Report to the Plan Commission

Legistar I.D. #24822
800 Langdon Street
Conditional Use Alteration

Requested Action: Approval of a major alteration to an existing conditional use to allow the renovation and expansion of the Memorial Union at 800 Langdon Street, including improvements to the north and west sides of Union Terrace and renovation of the adjacent shoreline.

Sheet No.	C-102
Scale	1/4" = 1'-0"
Date	10/20/2011
Author	JJR
Checker	JJR
Appr.	JJR
Project No.	0841K
Revision	1
Drawn by	JJR
Checked by	JJR
Appr. by	JJR
Scale	1/4" = 1'-0"
Date	10/20/2011
Author	JJR
Checker	JJR
Appr.	JJR

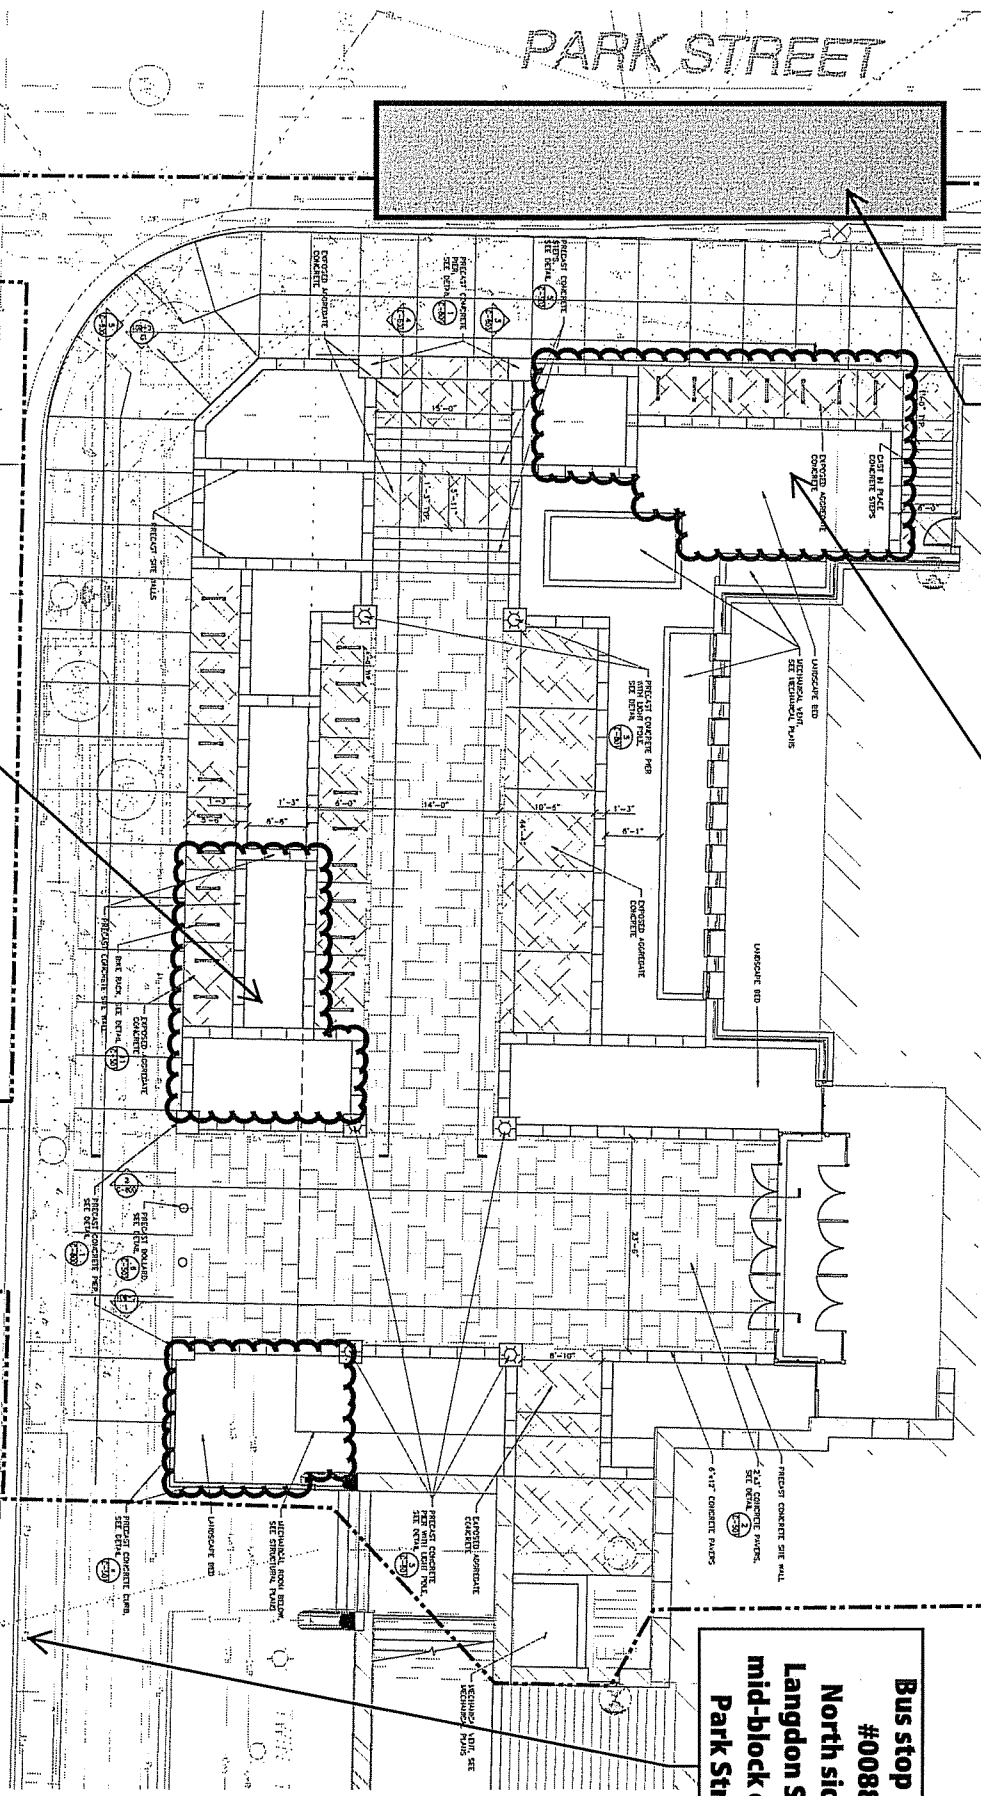
25. The applicant shall install and coordinate the maintenance for a new passenger waiting shelter with seating amenity on the east side of Park Street, north of Langdon Street. The bus shelter should be installed just south of the intersection with Observatory Drive.

26. The applicant shall install and coordinate the maintenance for a new passenger waiting shelter with seating amenity on the north side of Langdon Street, west of Park Street. The bus shelter should be installed a sufficient distance east of the intersection such that a stopped bus could depart the stop and proceed into the left turn lane onto southbound Park Street.

Bus stop zone #0095:
East side of Park Street, between Langdon and Observatory

General area in which to fit bus shelter

Bus stop zone #0088:
North side of Langdon Street, mid-block east of Park Street

General areas in which to fit bus shelter
